SAN DIMAS WASH 6 LEVEE SYSTEM LOS ANGELES COUNTY, CALIFORNIA NLD SYSTEM ID # 3805010067

PERIODIC INSPECTION REPORT NO 1 GENERALIZED EXECUTIVE SUMMARY

FINAL SYSTEM RATING: MINIMALLY ACCEPTABLE FINAL RATING DATE: FEBRUARY 27, 2015

Figure 1.2

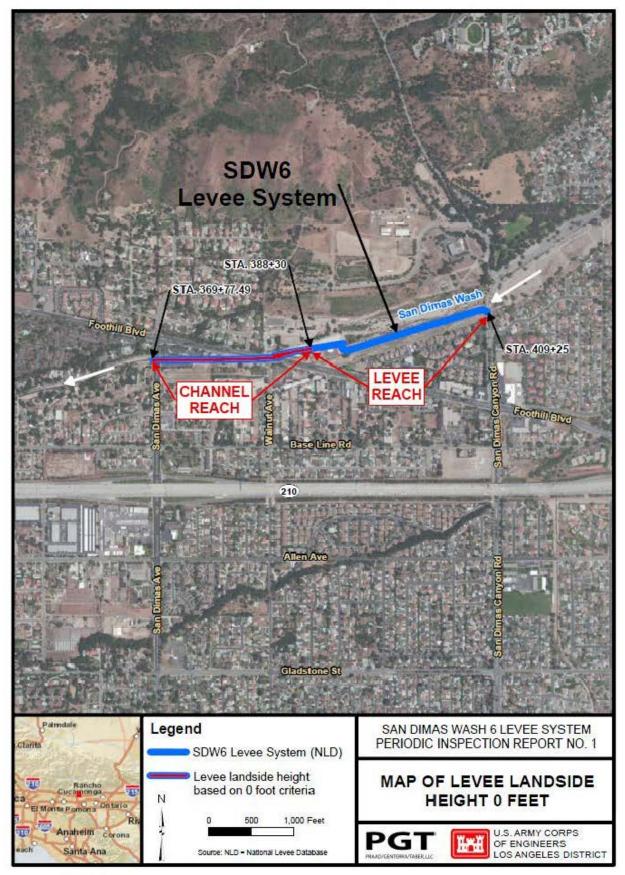
Based on field observations, the levee is 0 feet in height (landside levee toe to levee crown) from approximate STA. 388+30 to STA. 369+77.49, which is the recommended channel reach (see Figures 1.1 and 1.2). As a result, the length of the levee is recommended to change from 0.79 miles (per NLD) to 0.42 miles (per field observation), from approximate STA. 409+25 to STA. 388+30 (see Part 6). The levee reach is relevant to the Periodic Inspection of the levee system. However, the channel reach was separated from the levee reach to retain the channel reach information that was obtained during the field inspection of the levee system.
